**CONTRACT DOCUMENTS & TECHNICAL SPECIFICATIONS  
ADDENDUM NO. 2**

**Auburn Heights Preserve  
Paper Mill Bridge  
Contract No. 2015-NVF-100**

Project Name: Auburn Heights Preserve  
Paper Mill Bridge

Date of Issue: August 10, 2017

DESIGNED BY: RKK  
DRAWN BY: RKK  
BUILDING NO.: N/A  
DATE: 6/30/2017  
SCALE: 1" = 10'  
SHEET NO.: C-9  
PARKS PROJECT #: NVF-4  
CONTRACT #: 2015-NVF-100

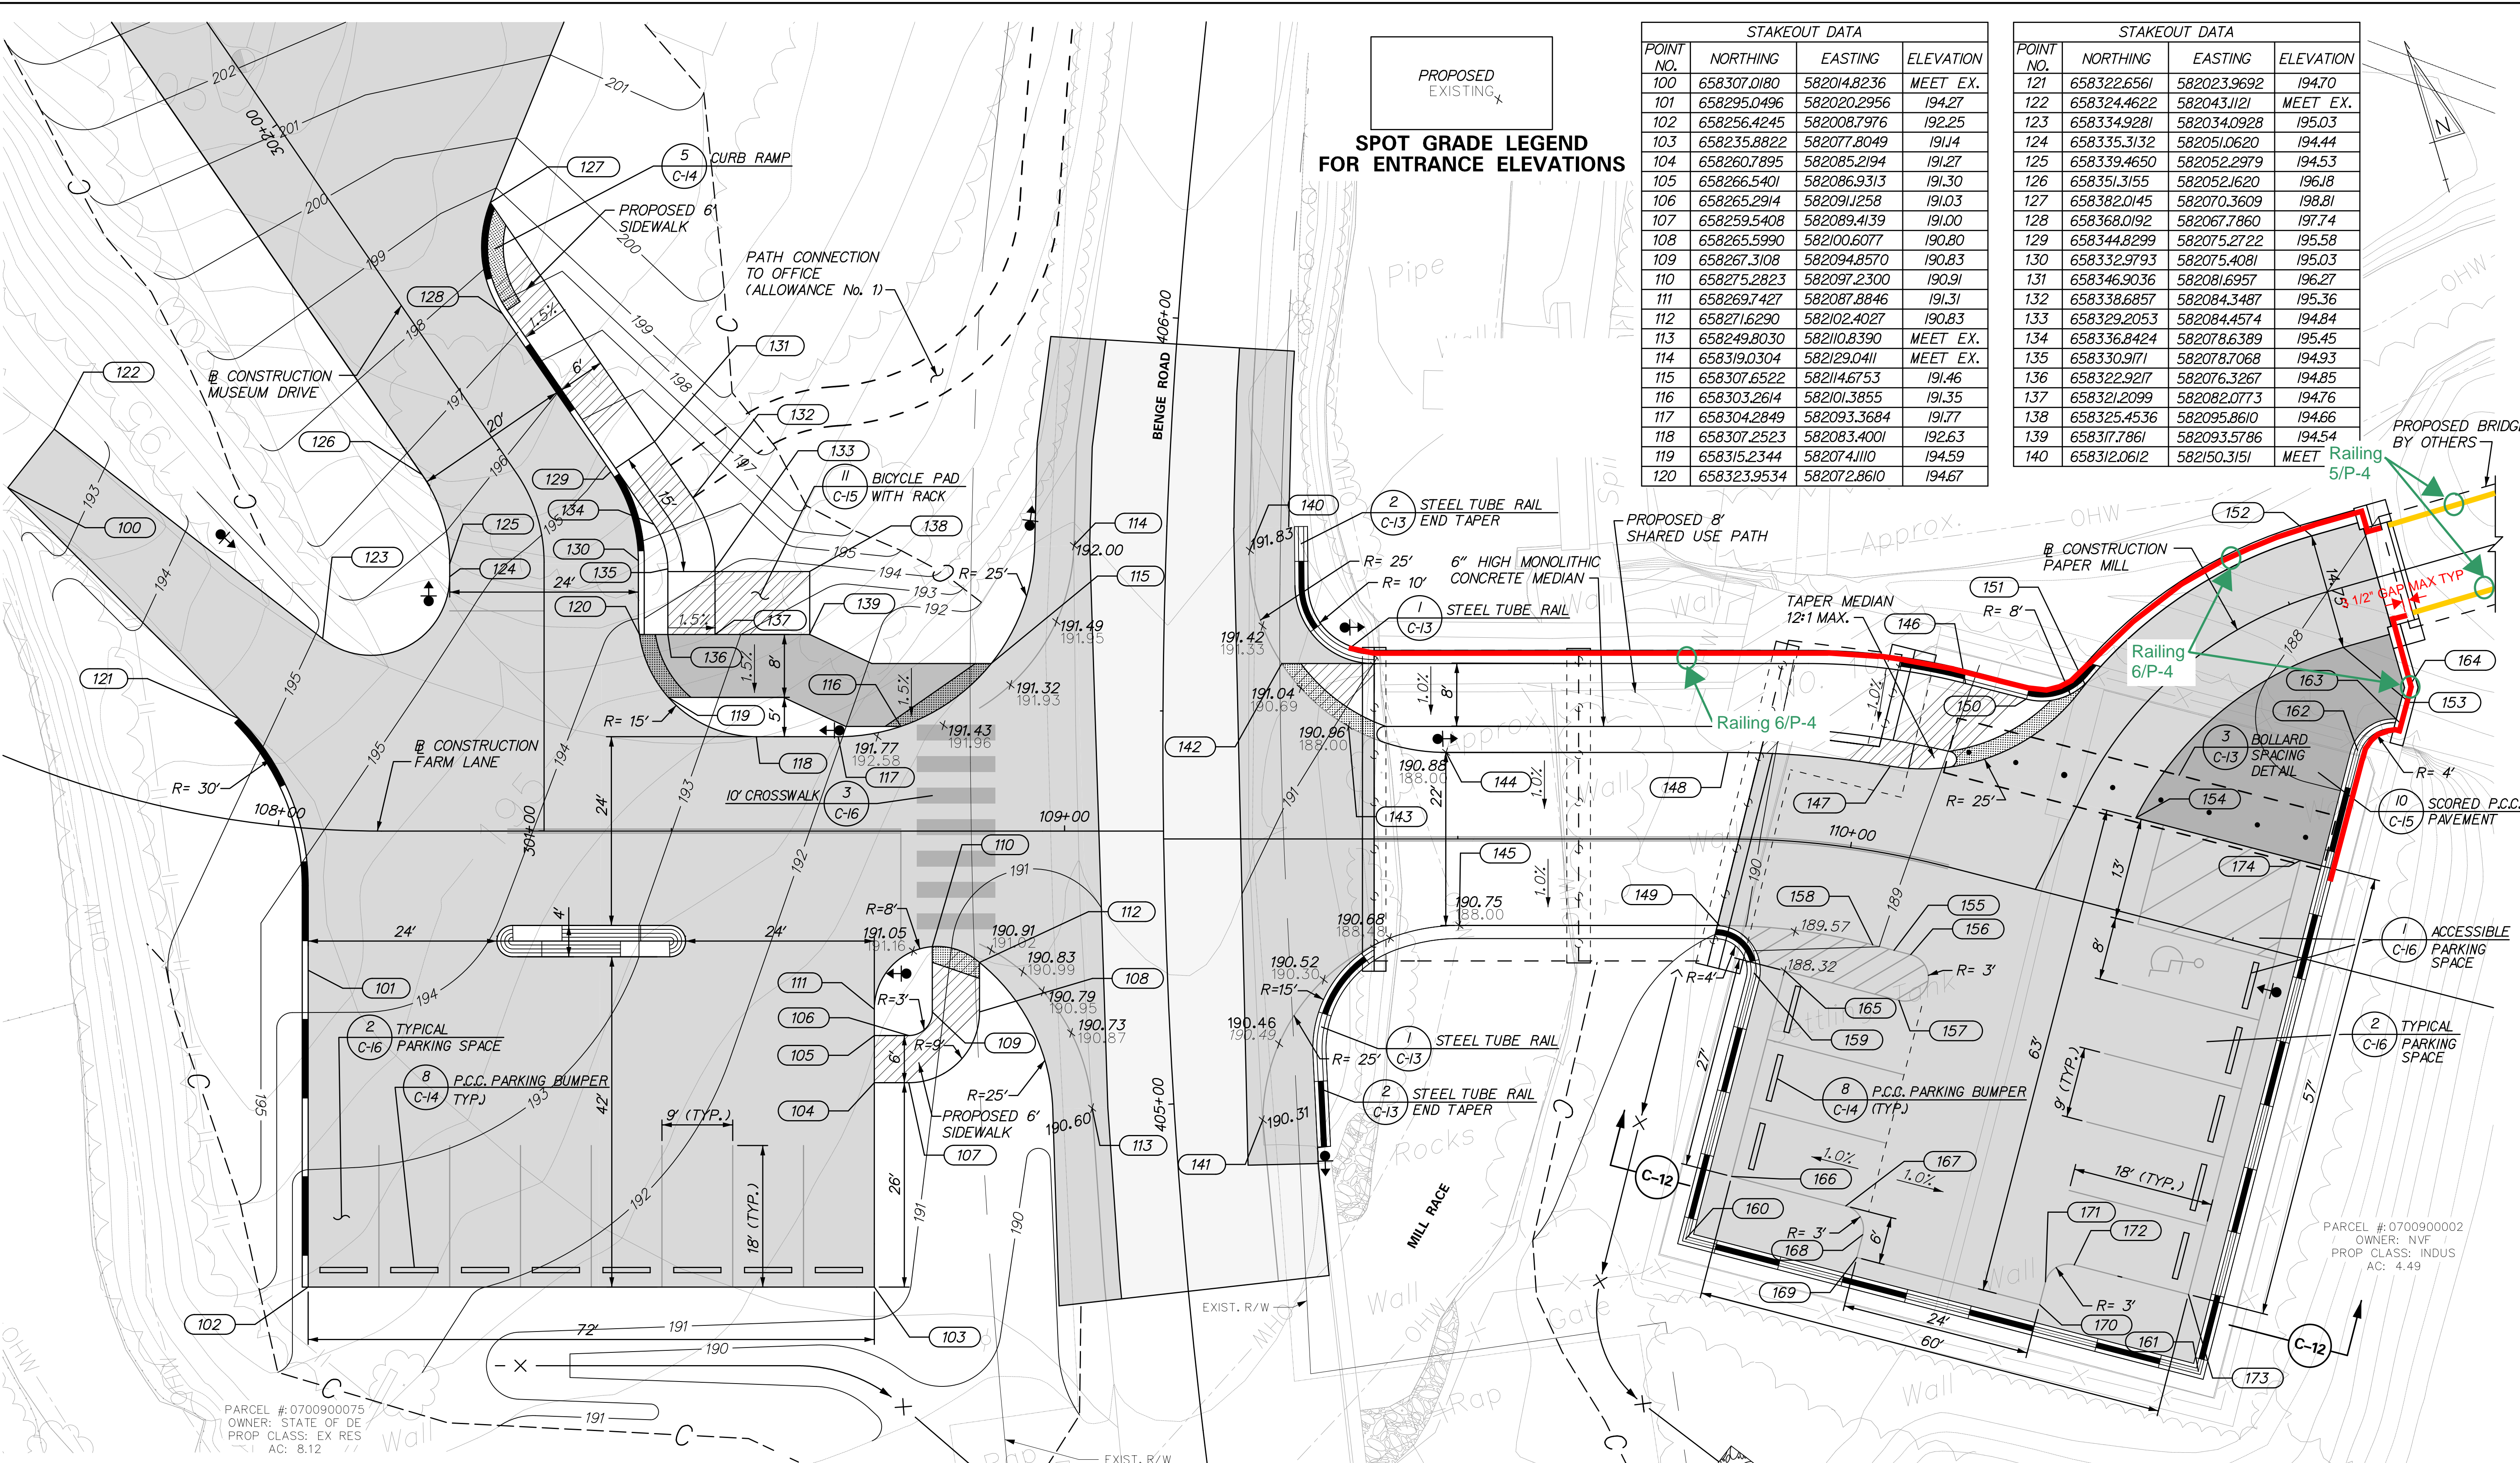
20. The 8' Shared Use Path next to the Bicycle Pad (west of Bengé Rd) is shaded the same as the Scored PCC Pavement near the Settlement Tank please confirm these are the same type of pavement and please provide the Pavement Section (i.e. 8" Concrete over 6" GABC)

**Response: The geometric layout for this area is shown on Sheet C-9. Notes was added to clarify the pavement and sidewalk section for this area. The revised sheet is included in this Addendum.**

**Response: The Shared Use Path next the Bicycle Pad shall be constructed of 6" of DelDOT Class B concrete over 4" of Graded Aggregate Base Course. A note has been added to Sheet C-9, and is included in this Addendum.**

BY:   
 DESCRIPTION:   
 DATE: 8/10/17   
 REVISIONS:   
 1. REVISED NOTES   
 2. REVISED SHARED USE PATH MATERIAL

DESIGNED BY:   
 DRAWN BY:   
 BUILDING NO.:   
 N/A   
 DATE:   
 08/10/17   
 SCALE:   
 1" = 10'   
 SHEET NO.:   
 P-5   
 PARKS PROJECT #:   
 NVF-4   
 CONTRACT #:   
 2015-NVF-100

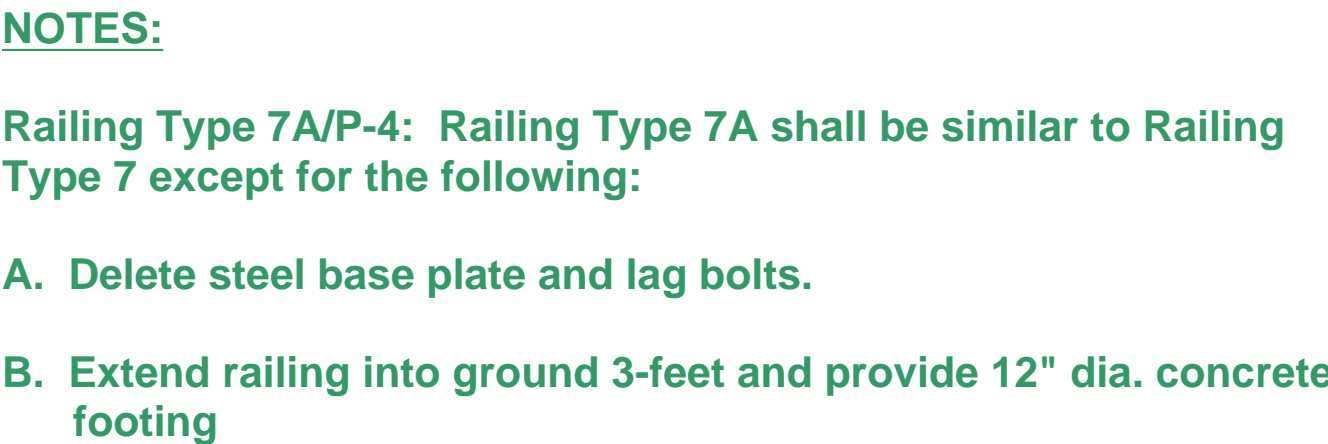
12. The pre-bid meeting minutes indicate that railing (from sheet P4) will be depicted on a new plan sheet. Will the plan sheet be issued soon?

**Response: New plan sheets P-5 and P-6 have been created to depict the railing locations and are included in this Addendum.**

SHEET NO.:  
ES-1

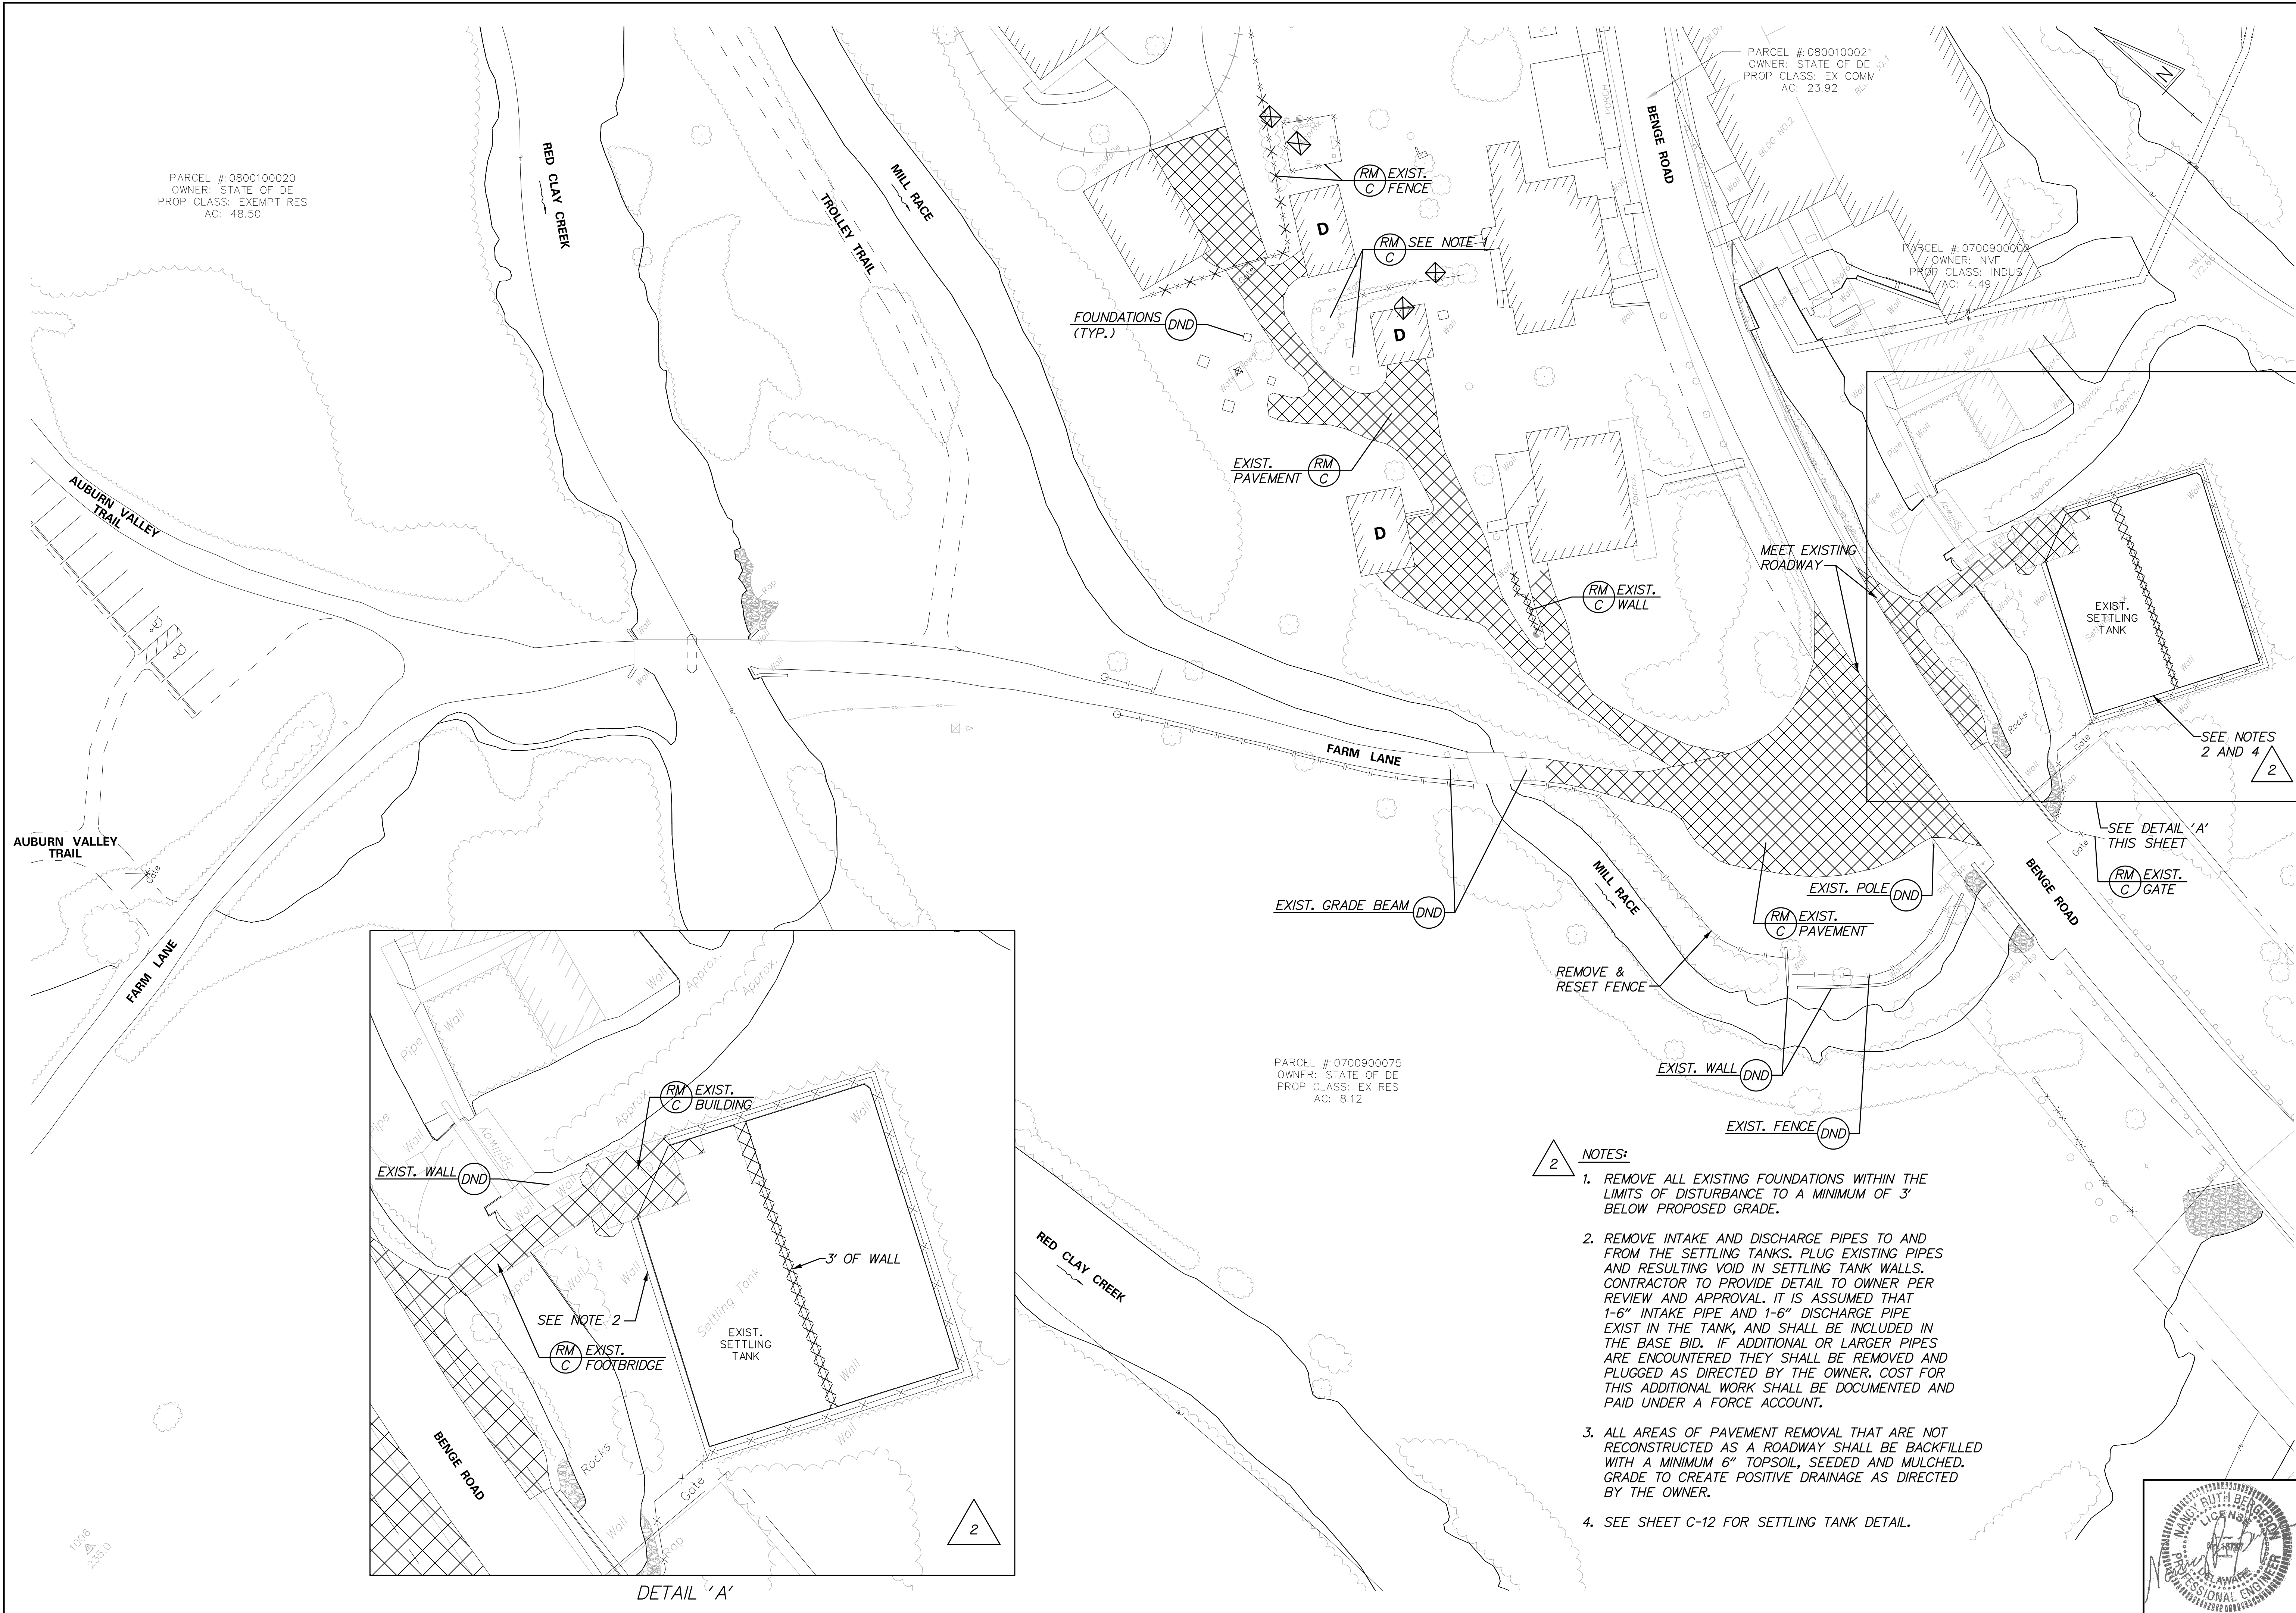
21. Plan Sheet ES-1 “Access to Paper Mill Bridge East Abutment” mentions restoration/redressing/addition of graded aggregate along the existing trail. This trail is not graded aggregate but hot mix asphalt, are we to include milling and overlaying this trail at the end of the project to restore to current conditions?

**The contractor shall remove the Access Road at the completion of construction. The area shall be backfilled with excavated material, seeded and mulched. Sheet ES-1 has been revised to add this note, and is included in this Addendum.**

REVISED AND ADDED NOTES
